**Response Action Outcome Completion Report for Medical Training Facility**

Westover Air Reserve Base Massachusetts

SUBJECT: Draft Final Response Action Outcome Completion Report for the Medical Training Facility site, Westover ARB, Massachusetts (Contract No. F41624-92-D-8036, Order No. 17)

# RESPONSE TO COMMENTS ON THE DRAFT FINAL RESPONSE ACTION OUTCOME COMPLETION REPORT

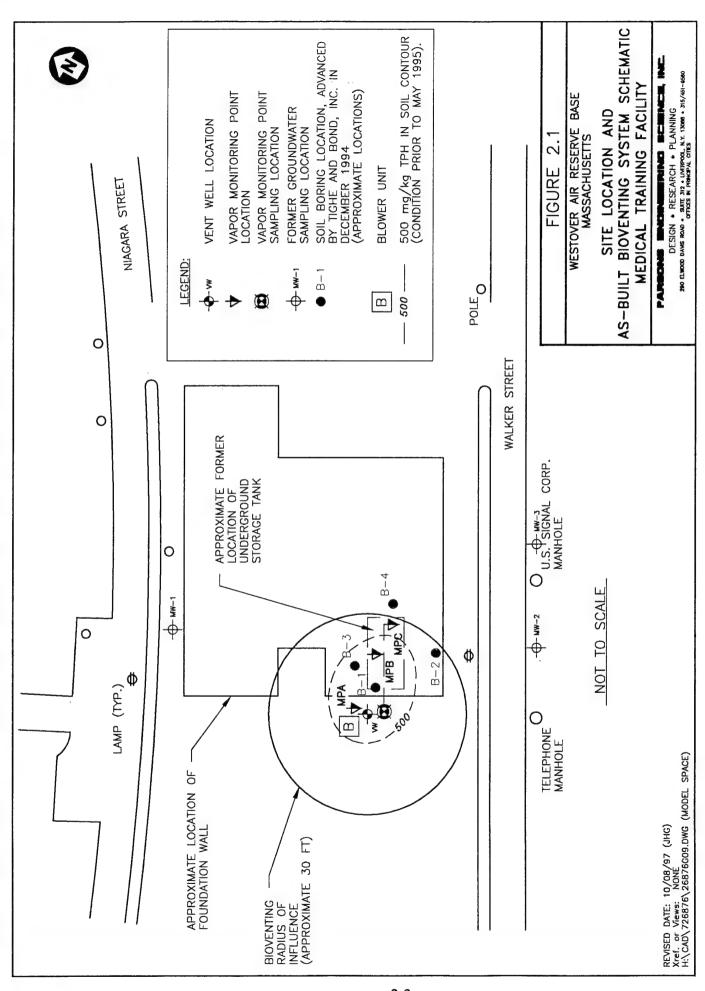
3) Page 2-3, Figure 2.1. Show the approximate location of the groundwater sampling point that ECS did in 1994.

Figure 2.1 has been revised to reflect this comment.

FIGURE 2.3 GEOLOGIC PROFILE

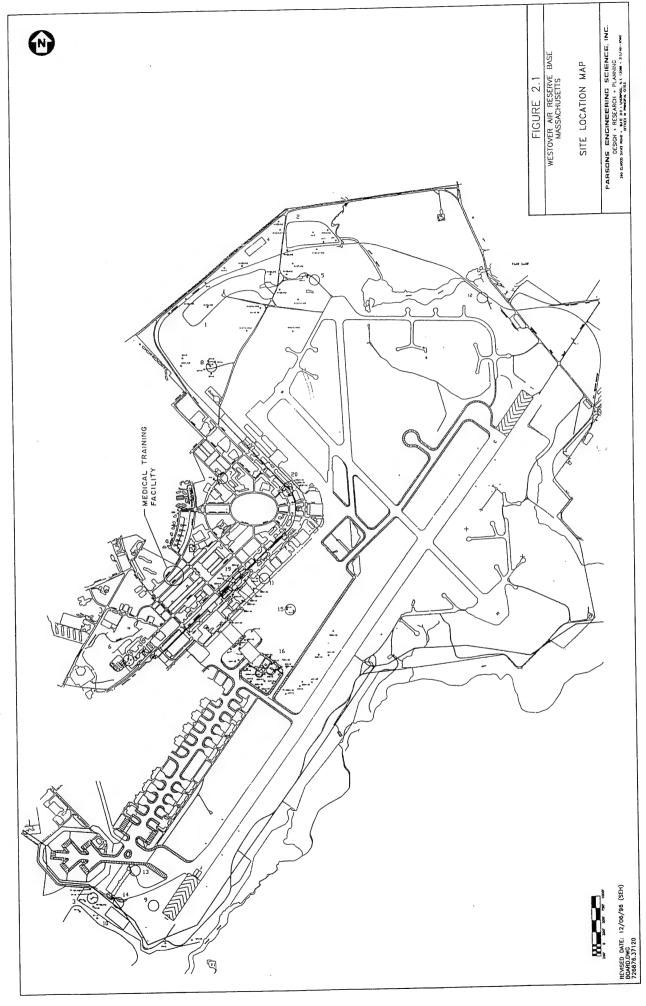
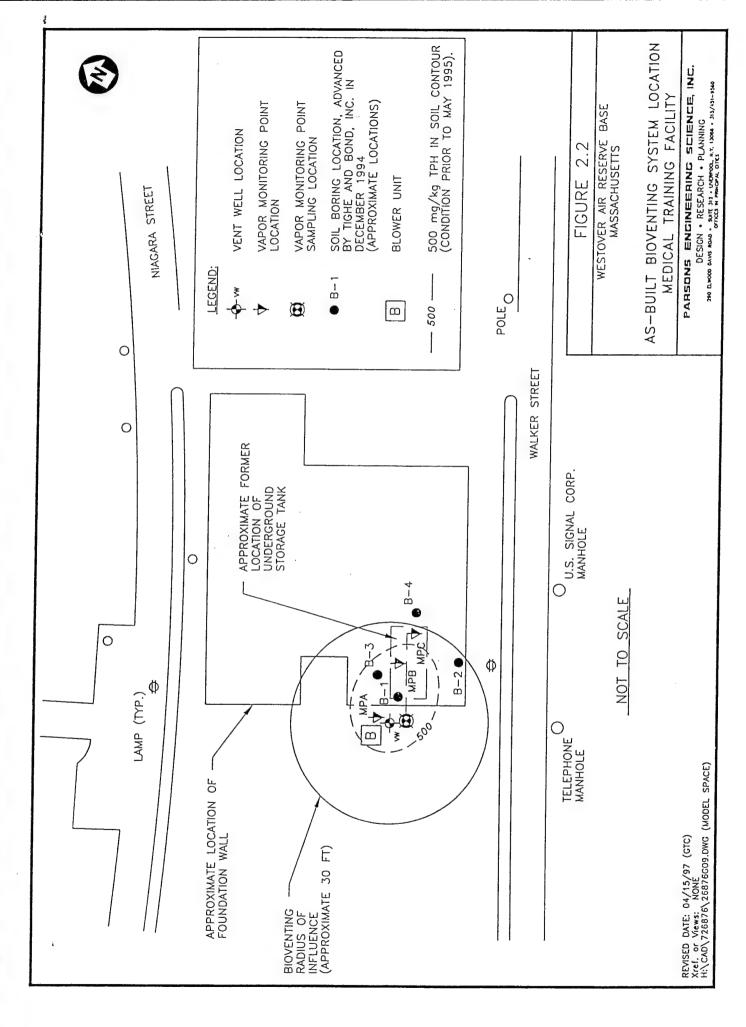
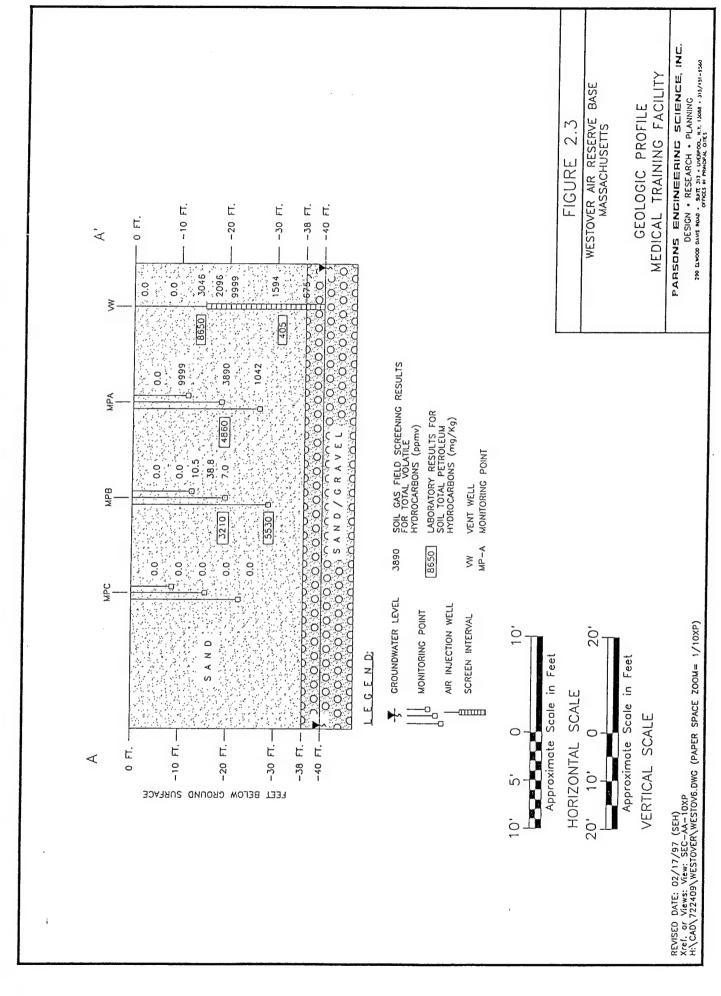
- 1. Figure 2.3. All the following refer to the field and lab sample:
  - a. Indicate in the legend text that the lab data are gas samples
  - b. Are the lab data ppmv or ppm?

- c. Please be consistent in upper/lower case. Field data is ppmv and lab data is PPM.
  - a. The following change has been made to the legend on Figure 2.3; "soil gas field screening results" has been added to replace "field screening results" in the legend on Figure 2.3.

- b. A note was added in the legend on Figure 2.3 that laboratory results are in milligrams per kilogram.
  - c. All upper case PPMs were changed to lower case.
